ADDENDUM NO. 1

April 23, 2024

Whiteland Community High School Phase 2A
300 E. Main Street
Whiteland, IN 46184

This Addendum consists of Pages ADD 1-1 through ADD 1-2 and attached Specification Sections 01 21 00 – Revised Contract Allowances, Logistics Plan, Guideline Schedule, and Lancer Associates Architecture Addendum No. 1, dated April 23, 2024, consisting of 63 Pages, Specification Sections 11 68 33 – Field Events & Athletic Equipment, 32 18 23 – Track Surfacing Latex System, 32 31 13 – Chain Link Fencing and Gates, 33 14 17 – Site Water Utility Service Laterals, 33 42 00 – Stormwater Conveyance, and Drawings 100, 210, 302, 303, 400, 401, 402, 403, 500, 501, 600, 601, 700, 900, 901, 902, 903, 904, 1004, L101, L102, L201, L202, L402, ES102, ES103, and ES301.

4. Site Dimension Plan (sheet 302):

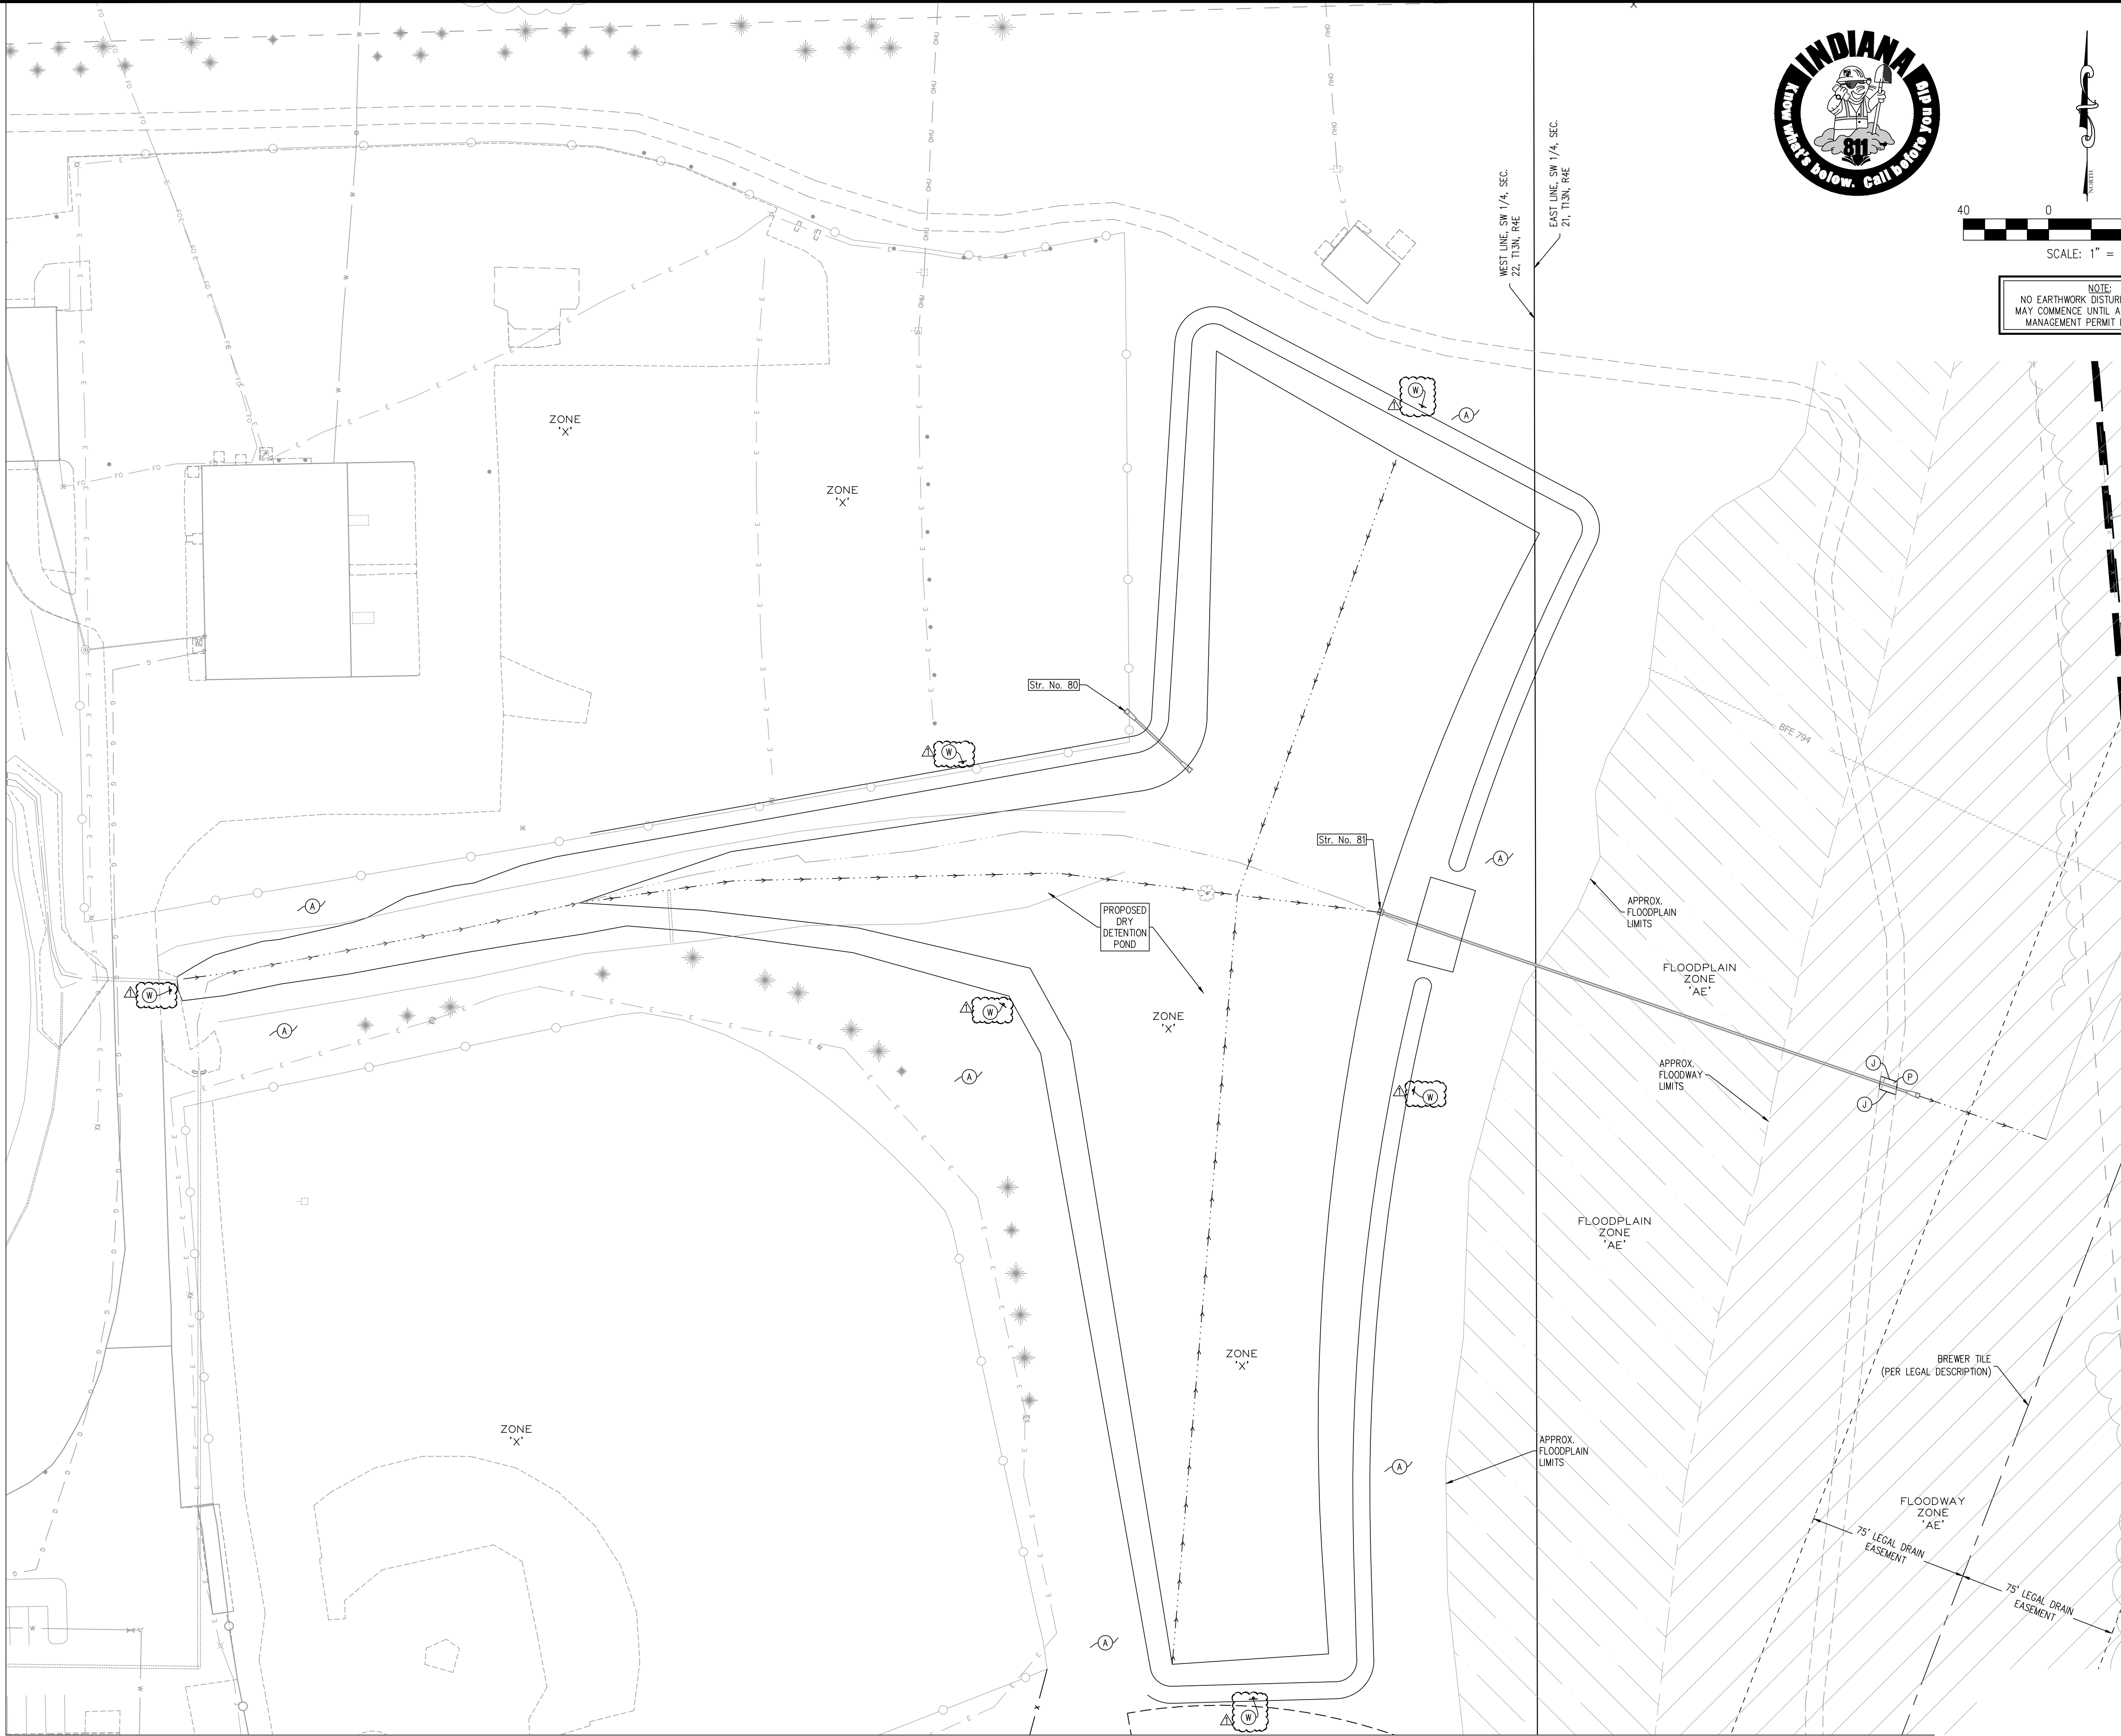
- o Revised to include warning signs around proposed dry detention basin.

5. Site Dimension Plan (sheet 303):

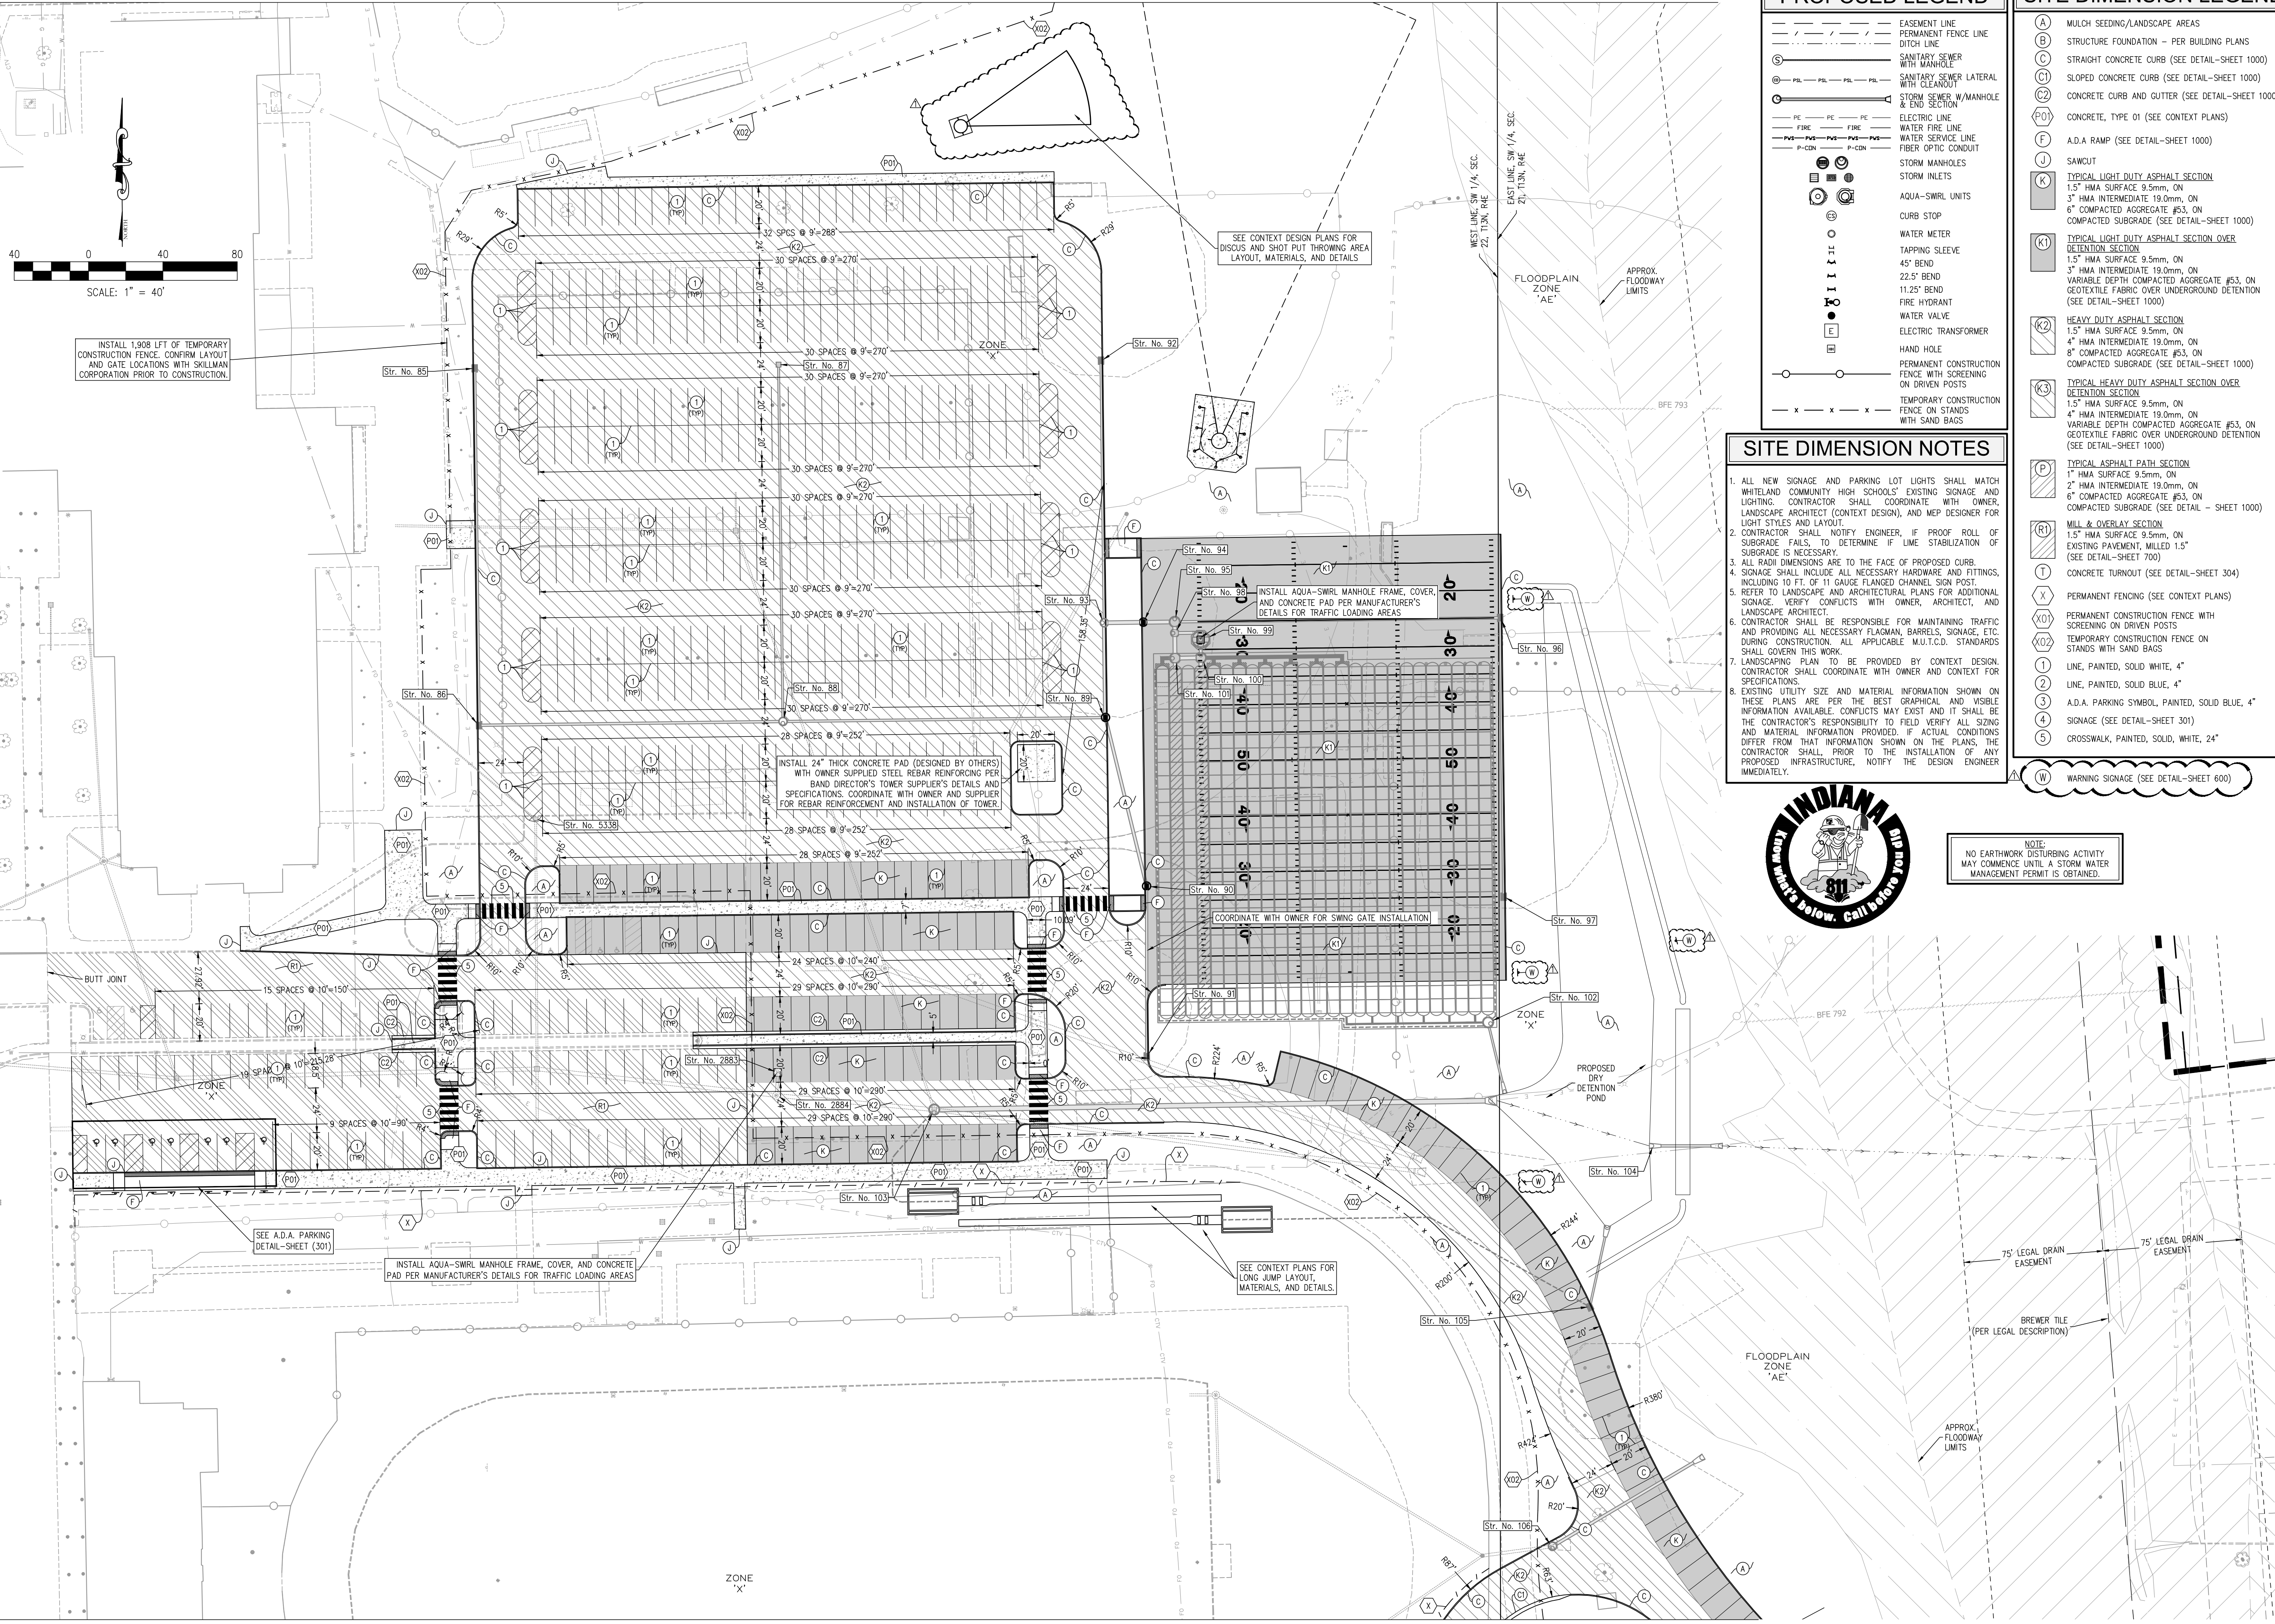
- o Revised location of proposed shot put throwing area.

- o Revised to include warning signs around proposed dry detention basin.

SHEET 400

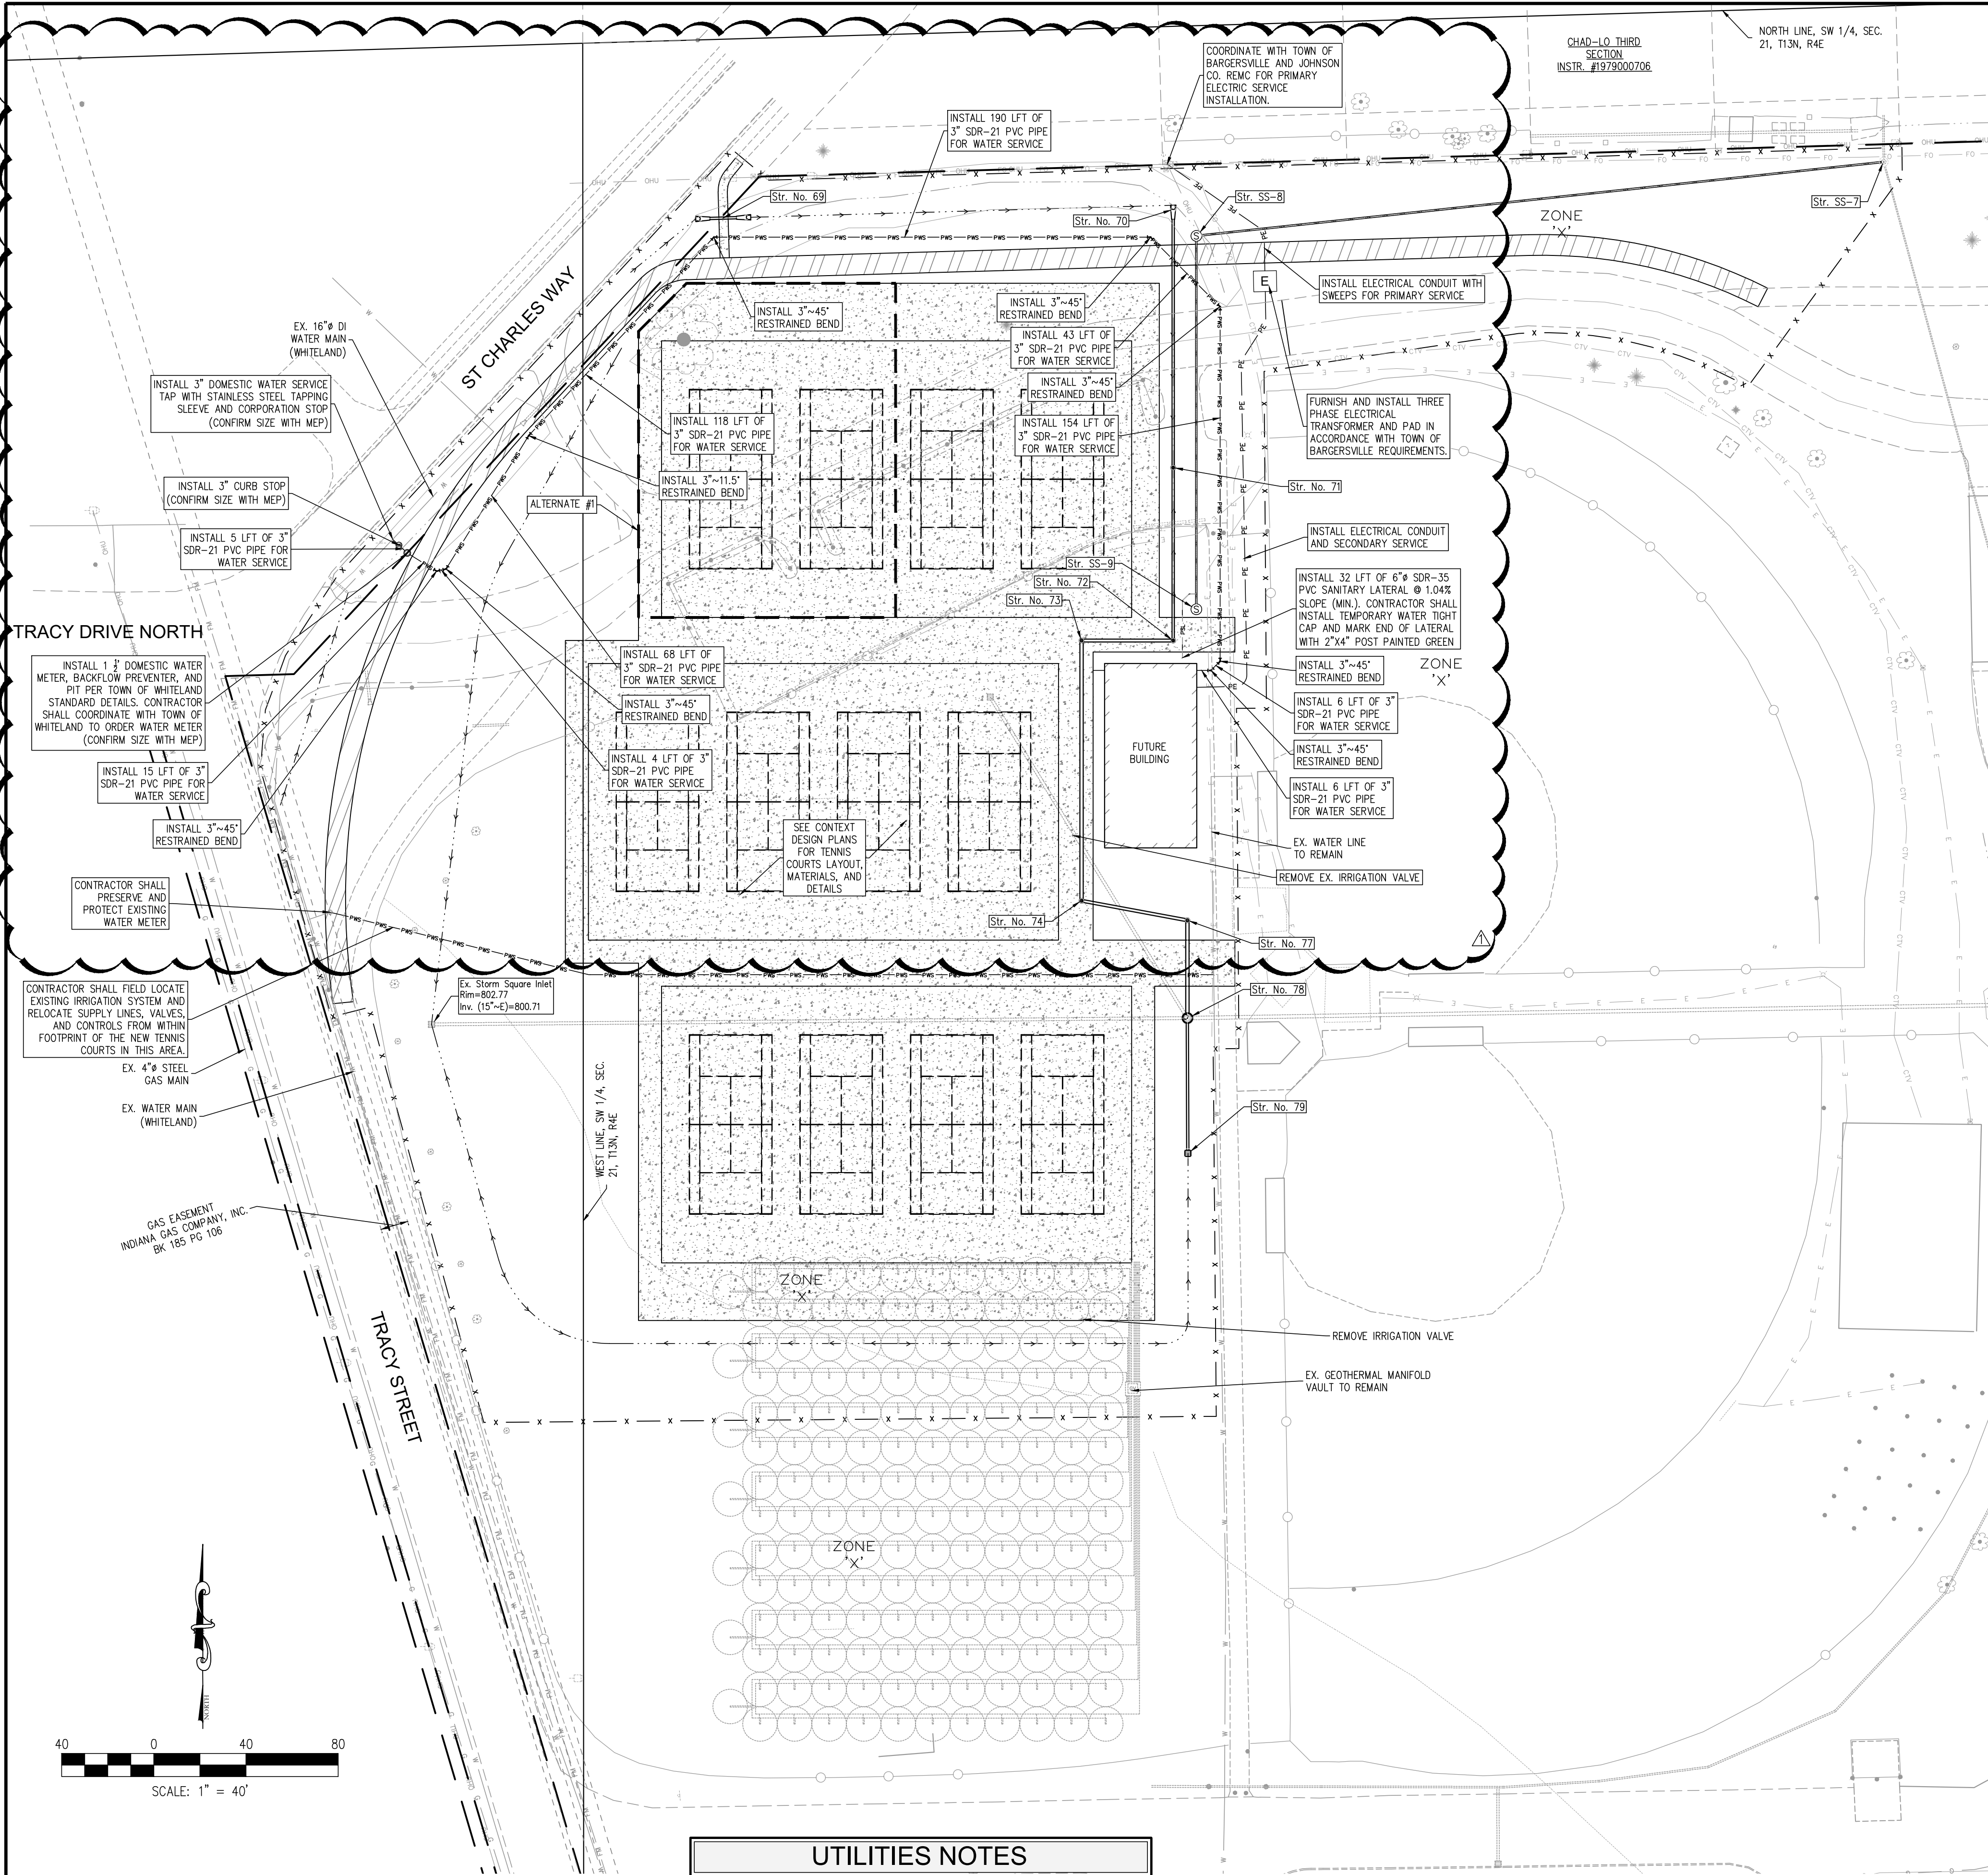
- o Revised to include domestic water service tap, meter, meter pit, and water service line for future tennis building.

- o Revised sanitary sewer main and lateral layout so proposed lateral for future tennis building connects to the sewer main instead of the manhole. Revised Sanitary Sewer Structure Table based on revised layout. Remove sanitary lateral cleanout.

- o Revised Storm Culvert Data Table to indicate animal guards are required in the pipe end sections for Str. No. 69.
